U9405B-02

Modification Recommended Service Note

U9405B - FlexiCore Parallel ICT and FlexiCore FlashStation

The Problem – Handler Control Panel cannot detect Fixture Control Board sensors states

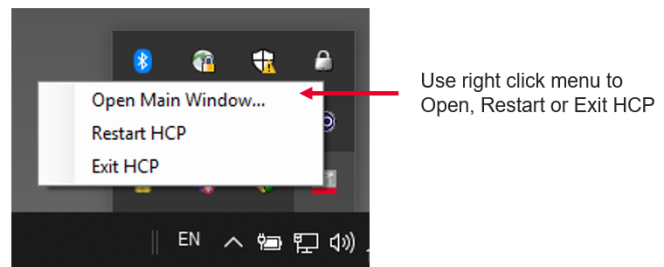
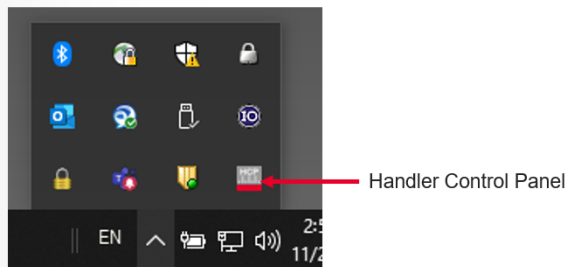
Due to the cut in of Windows 10 version to 2004 and above on all new FlexiCore systems, the Cypress chip firmware on the Fixture Control Board had been updated from 0404 to 0405 to support the new digital signatures requirements by Win10.

The change causes all versions of Handler Control Panel application to lose communications to the firmware. Handler Control Panel can no longer detect the states of the sensors from the Fixture Control Board. However, certain operations like Initialize still works.

Handler Control Panel version 3.0.4.0 (HCPv3040) has been released to fix the problem. Handler Command version 1.2.8.3 has been released to support the new features of HCPv3040. Send an email request to kwan-wee_lee@keysight.com for the download links.

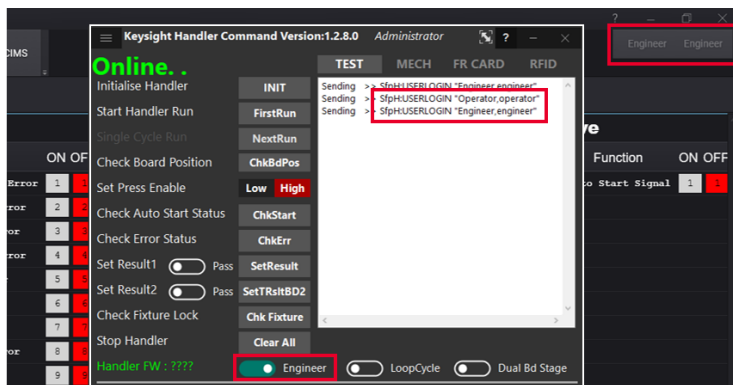
To prevent unauthorized access to the control of the handler, HCPv3040 will startup in Operator mode by default. In this mode, user can only view the states of the sensors and cannot perform any handler operations such as Initialize or Conveyor Width adjustments.

The only way to unlock HCP into Engineer mode is via a command to the HCP SCPI server. To do this, user just need to launch the Handler Command application in Administrator mode and the application will automatically send the command to set HCP into Engineer mode. User can then toggle between Operator and Engineer mode from the Handler Command interface.

Engr/Opr access control

HCP starts into Operator access

Requires `USERLOGIN cmd` to change access level

Username can be customised to any name

Supports only “engineer” and “operator” levels.

Users are recommended to make use of the Handler Command application to perform any handler operations such as Initialization and Conveyor Width adjustments. The application also provides a range of other actions and features which will help in system setup or troubleshooting. User can access the documentation for Handler Command by clicking the “?” icon on its interface.
